CODE CHANGE PROPOSAL FORM

Topic of proposal: Radon (MN Rule 1303)

Code or Rule Section: **1300.0040
Subp 2**

change language contained in an existing amendment in Minnesota Rule? If so, list Rule part(s).
1303.1600, Subp. 1 Footing Depth for Frost Protection

FIGURE 7. Column Foundation (Unheated Building)

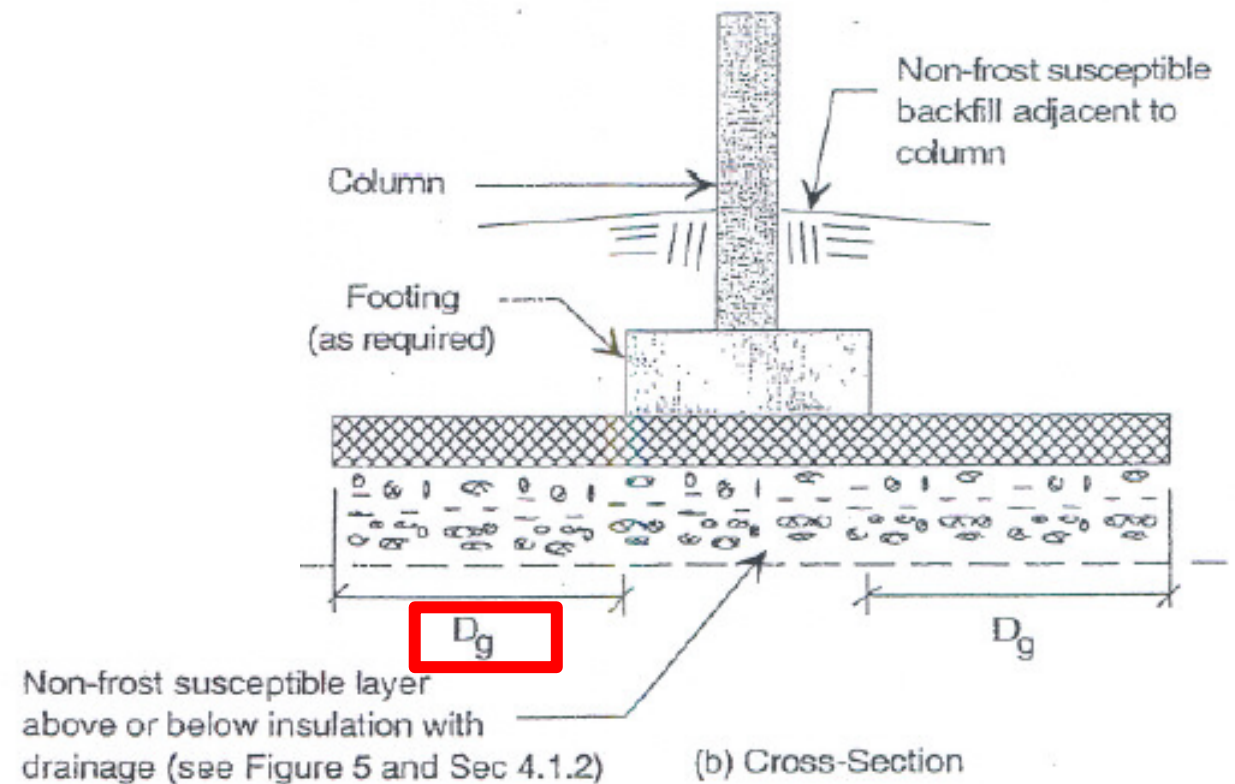
D_g is the width of the HORIZONTAL projected insulation required under the footing to keep the ground from freezing.

- D_g can be reduced by 1.25 inches for every inch of depth below grade beyond 10" depth.
- For required frost depth without horizontal insulation D_g must be reduced to zero.

Air Freezing Index- Frost Depths

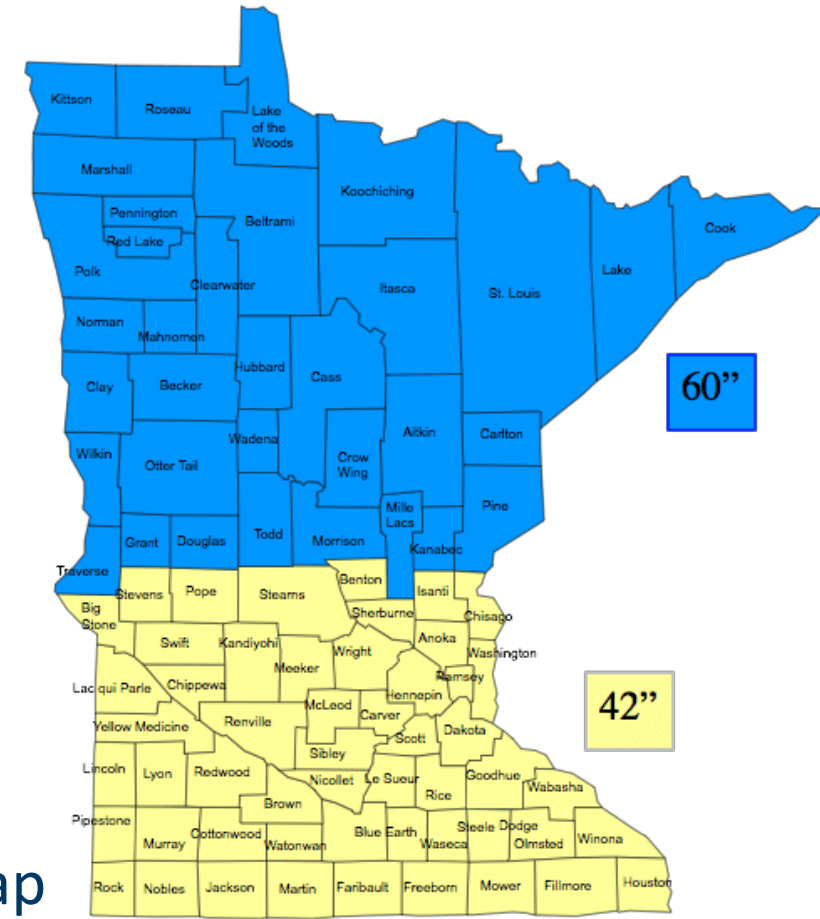
Current Map
